**APPLICATION FOR  
URBAN DESIGN COMMISSION  
REVIEW AND APPROVAL**

6500 Normandy Lane  
91 Unit Condominium Building PUD (UDD – SIP) Submission

### Design Revision

Per your design review comments of April 25, 2007, we have incorporated the following revisions.

SECOND, THIRD, &  
FOURTH FLOOR PLAN

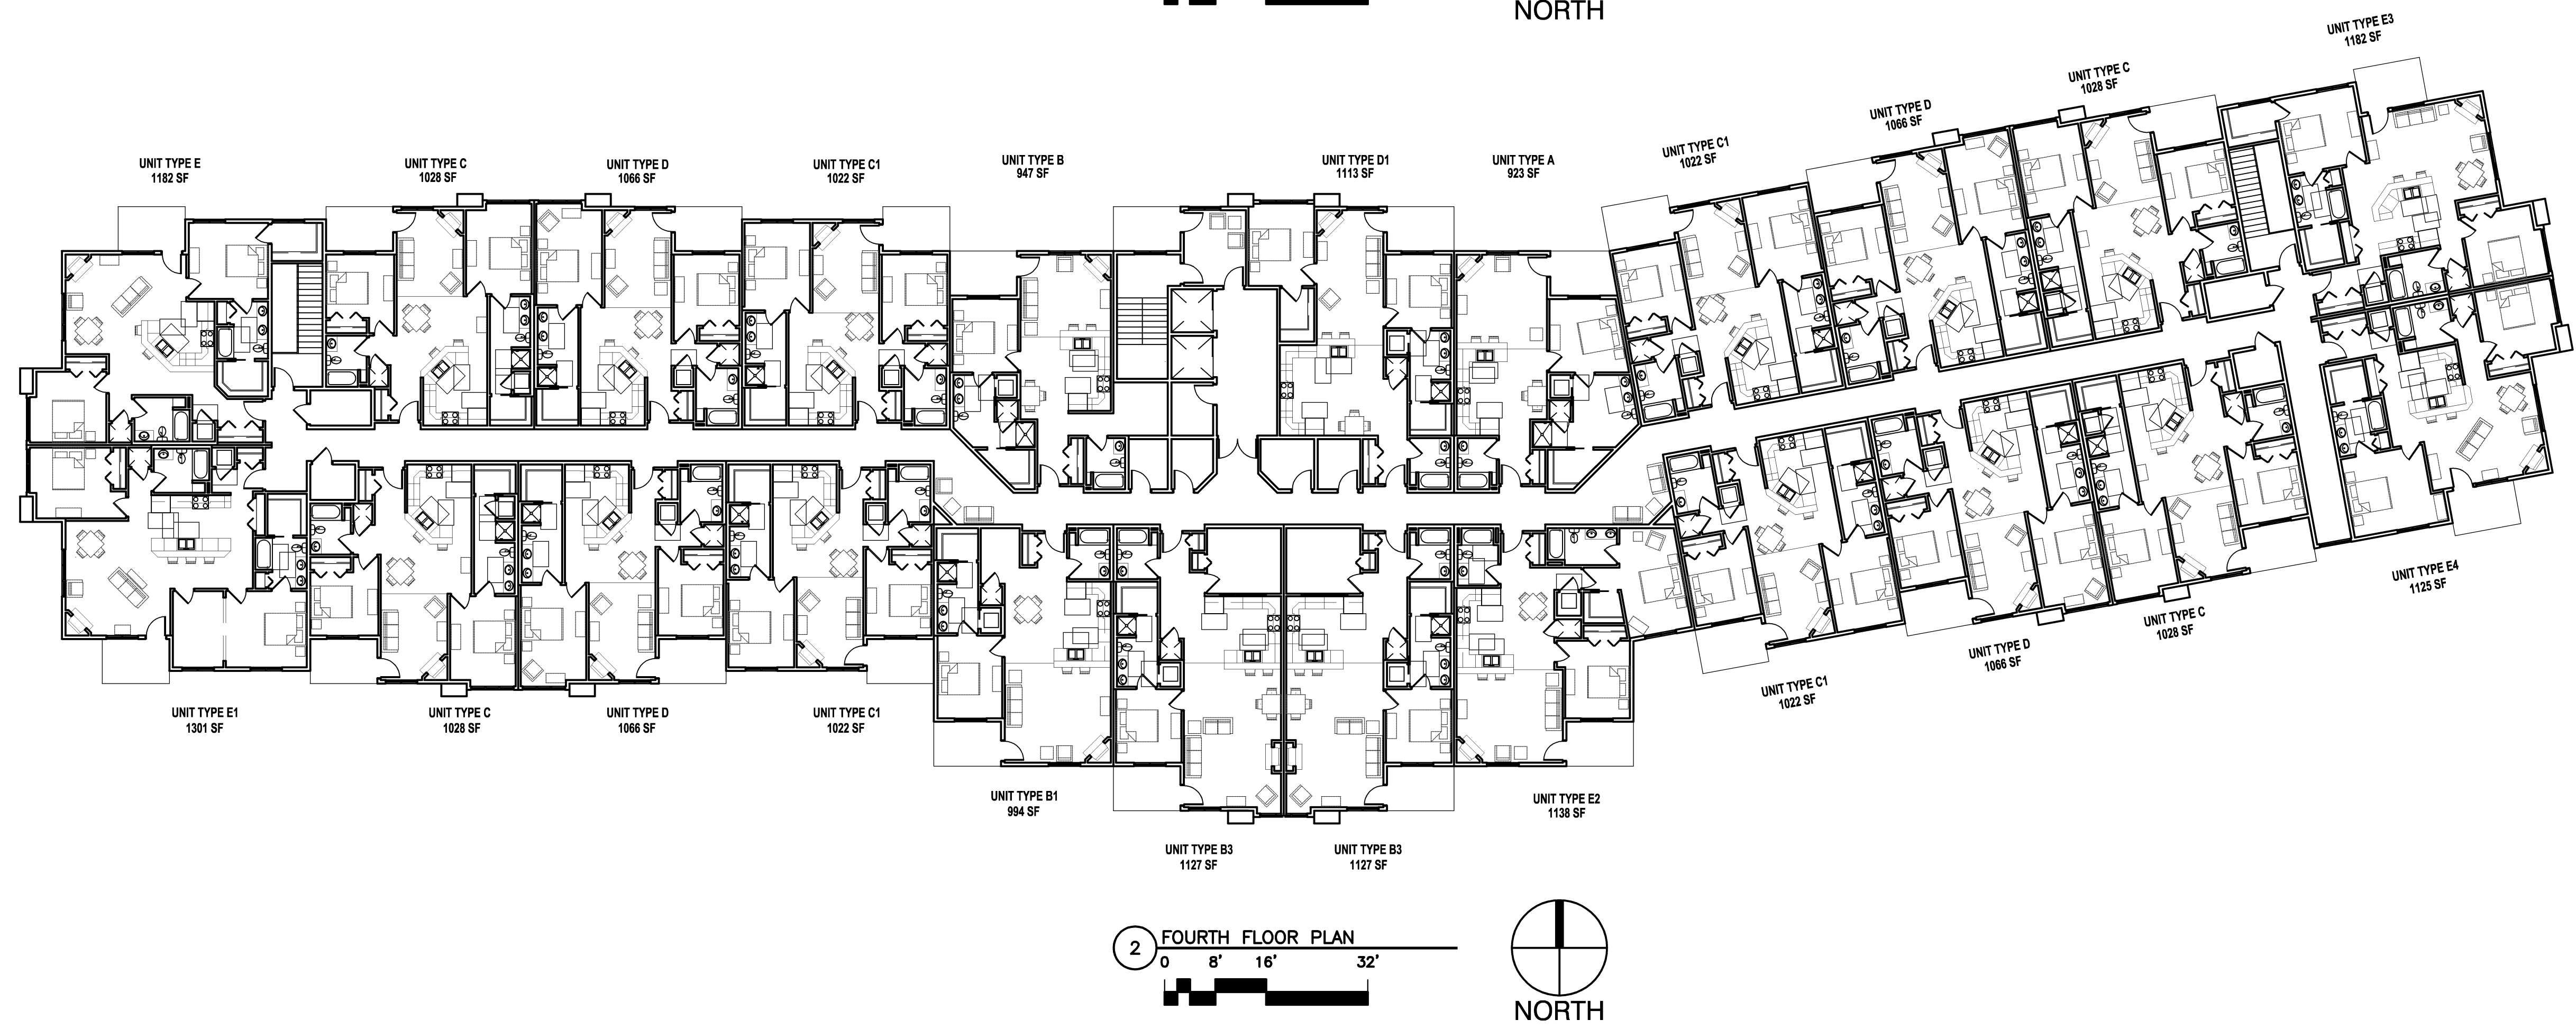
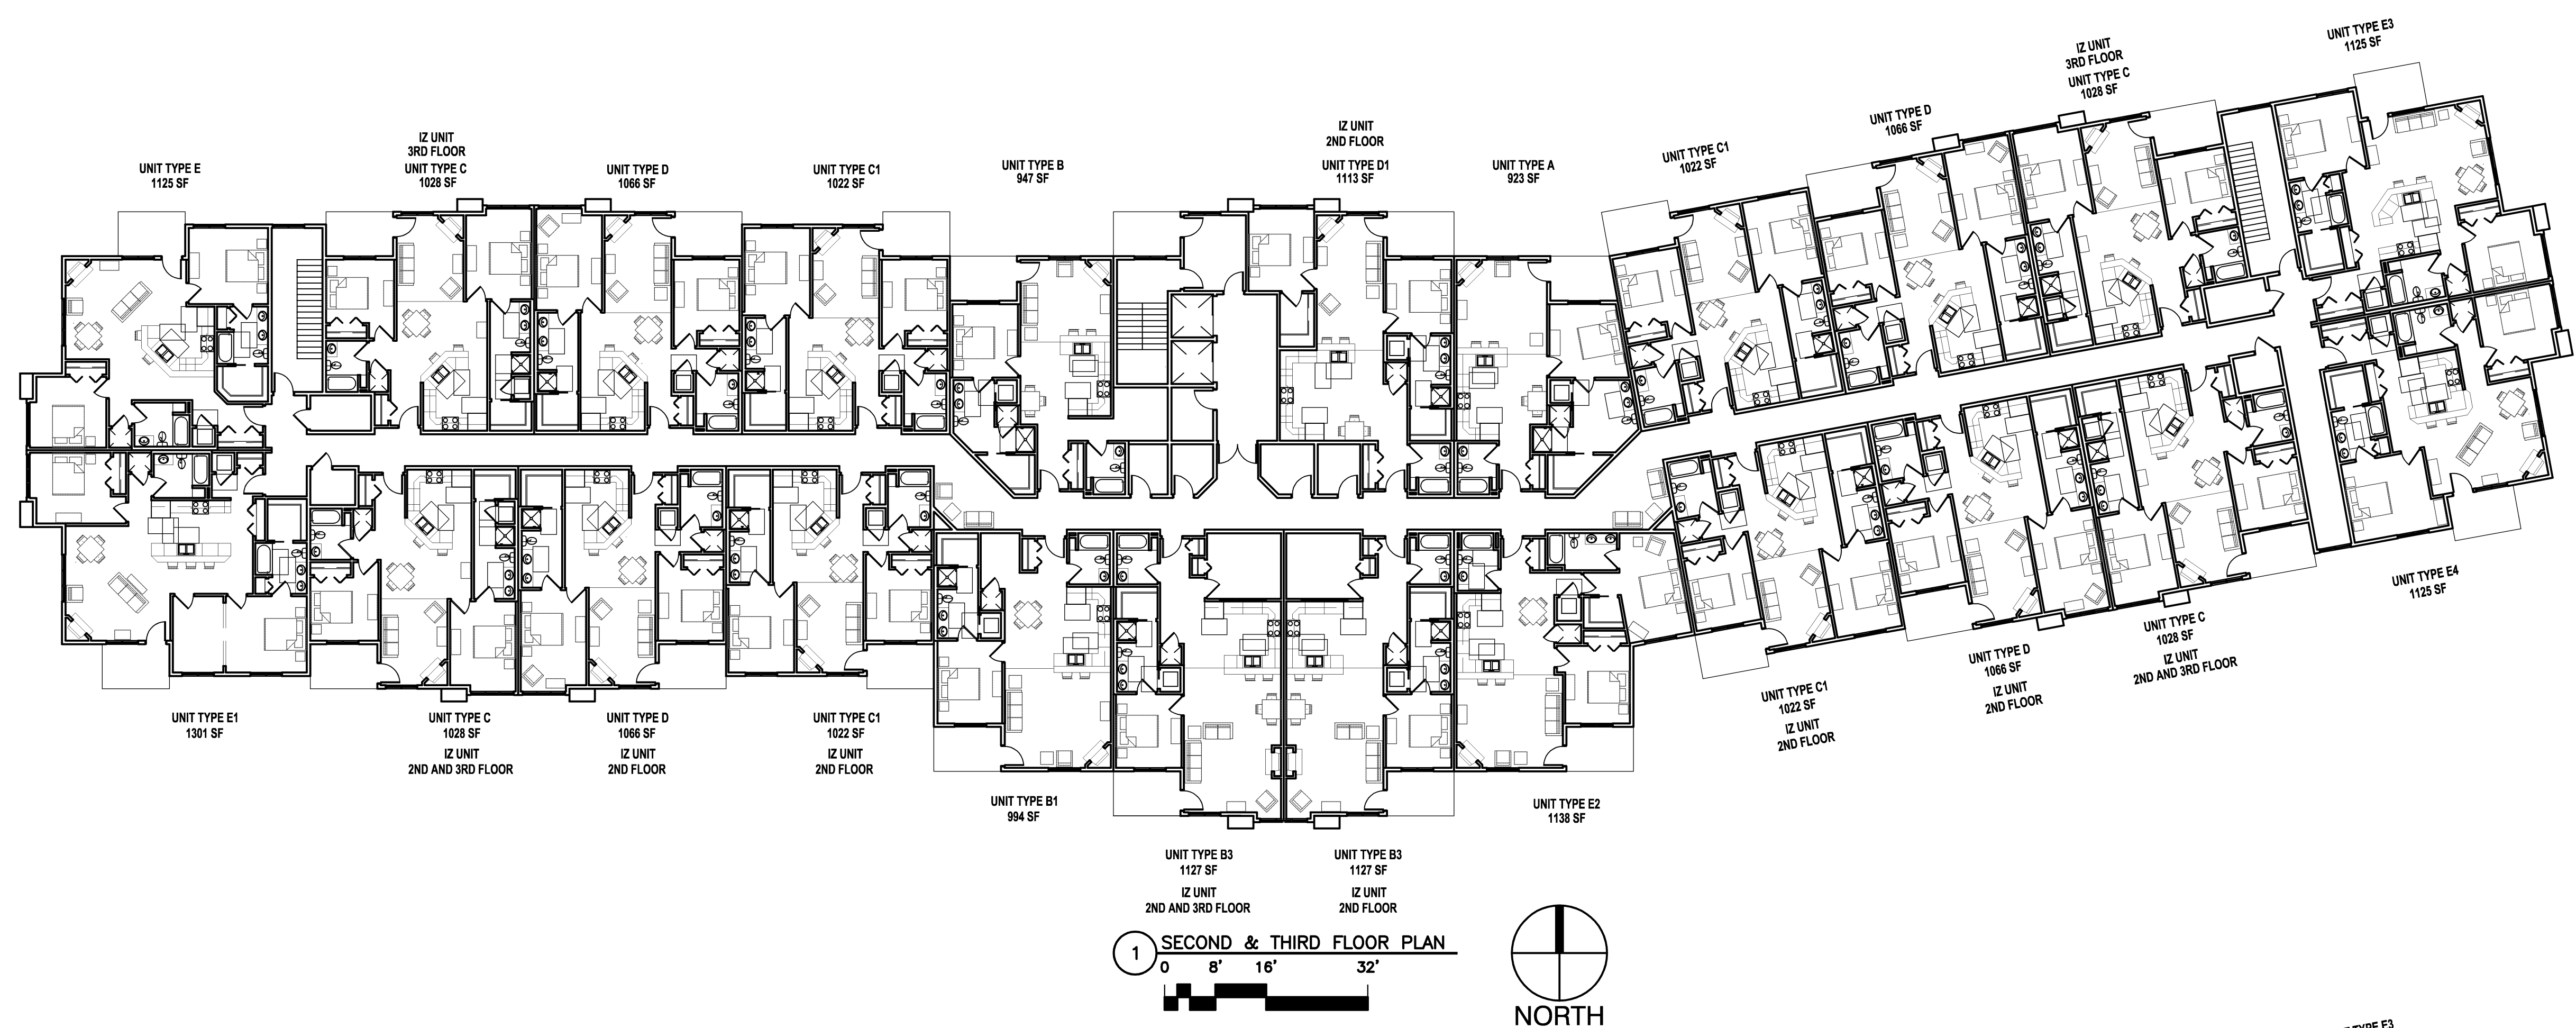
- The main entrance and activity room has been relocated to the Normandy Lane side.
- A small activity room and patio has been located off of each levels lobby.
- The jogs in the corridor have been widened to create informal activity areas and break up the corridor.

EXTERIOR  
ELEVATIONS

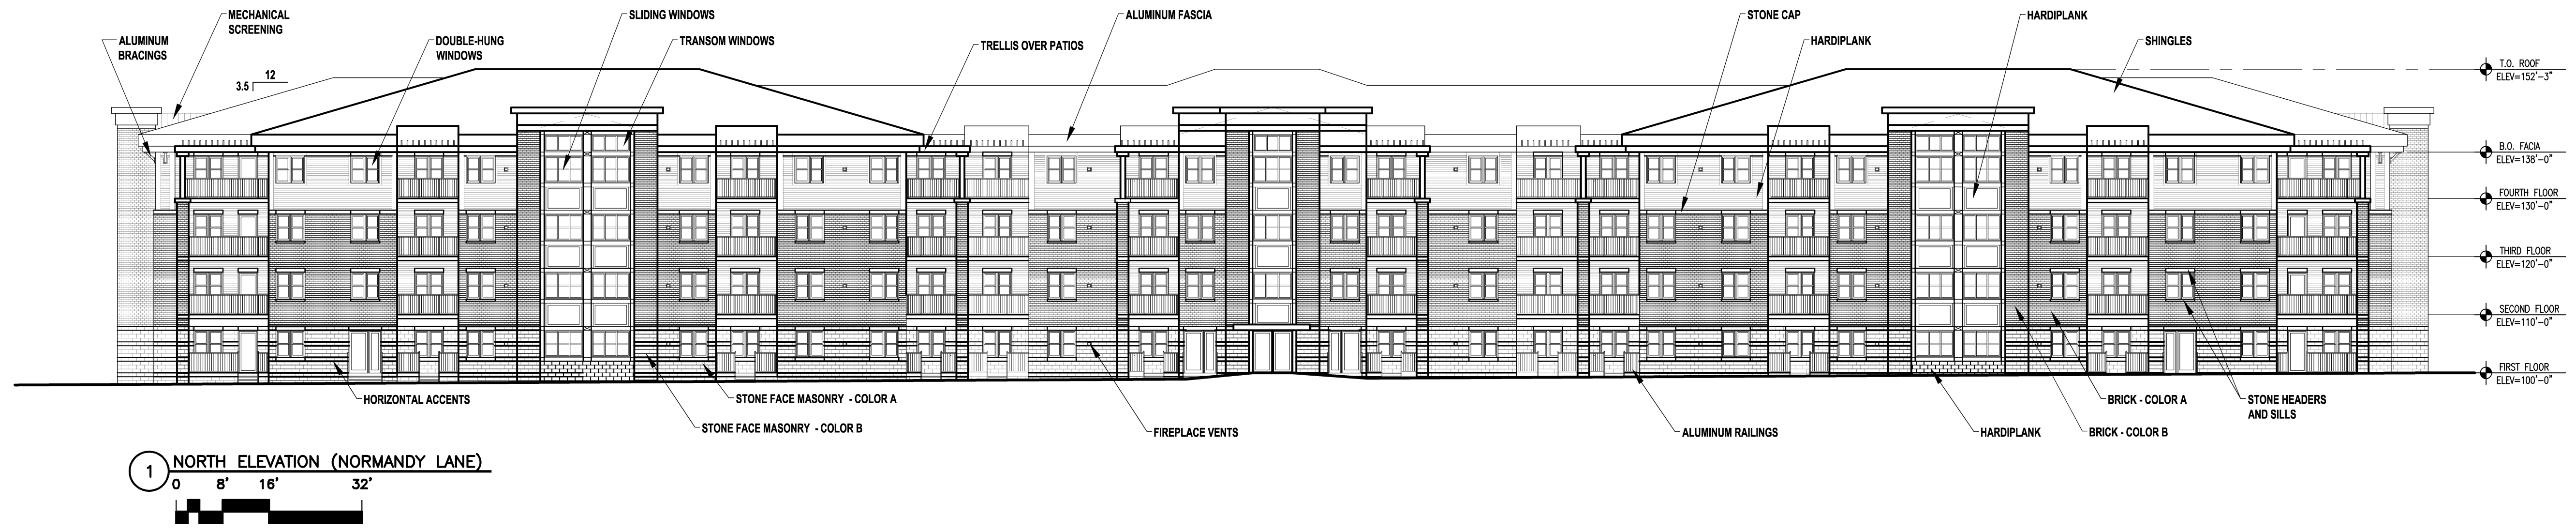
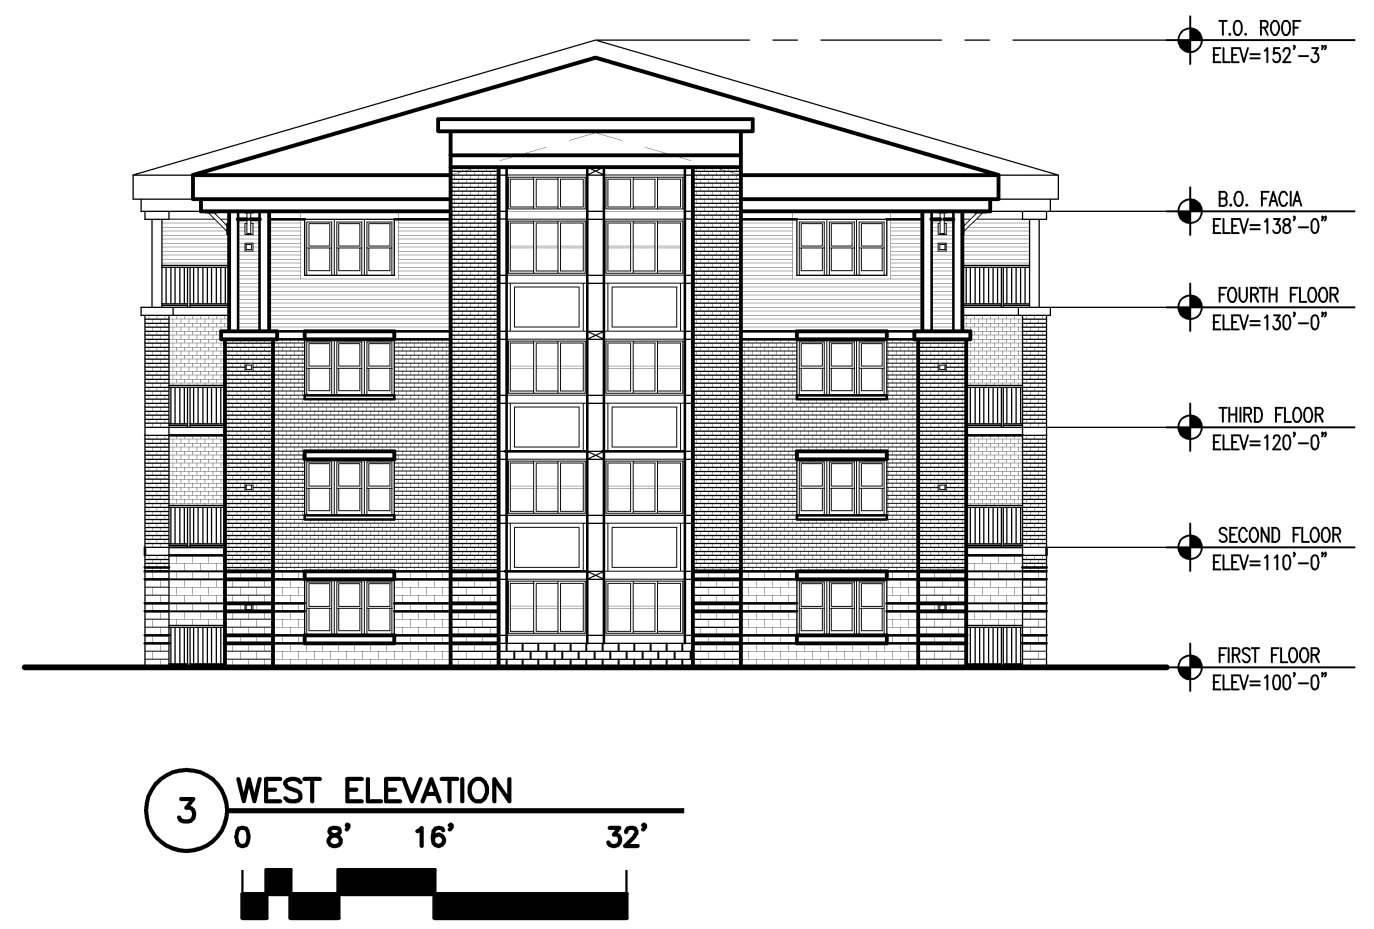
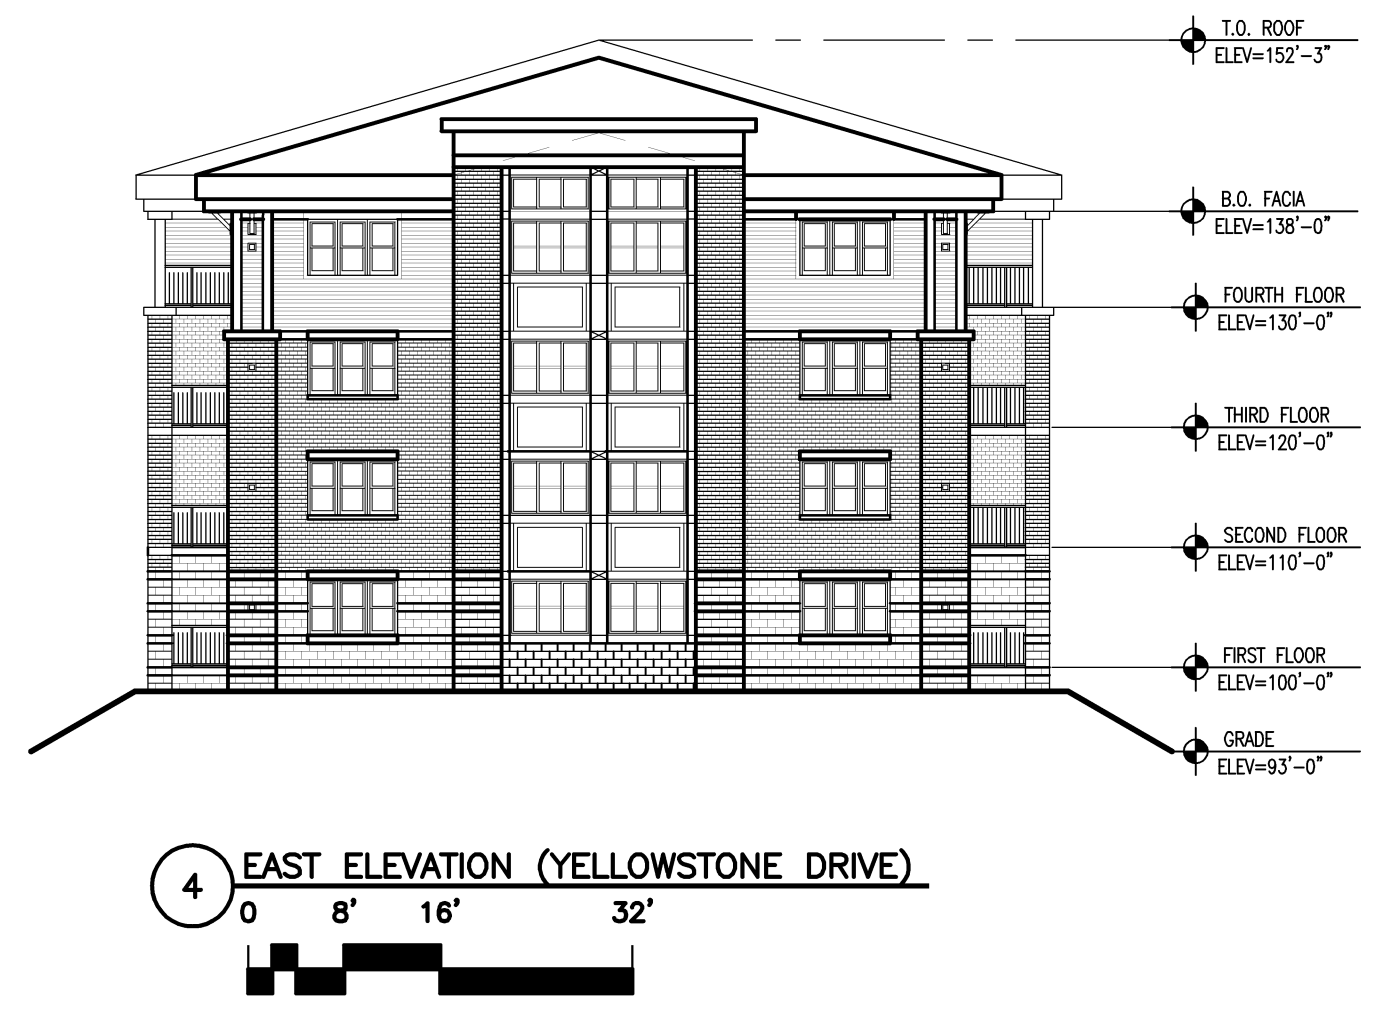
- The building base has been revised to provide masonry material with offset bands to provide a more pedestrian scale.
- The roof edge has been revised to provide a heavier/wider more urban roof edge that ties into above the head of the windows. Ornamental brackets have been added at the corners to provide visual support of the roof fascia/soffit.
- The columns at the decks and patios have been revised to provide a stronger connection to the building. Masonry has been added to the lower three levels.
- The roofs at the corner patios have been pulled back to allow more light in. Arbors have been added at the top decks.
- The projecting bays on the building have been revised to have a flat parquet capital to provide a more urban image and stronger presence. EIFS has been eliminated for the project. Cement board is being used in these areas.
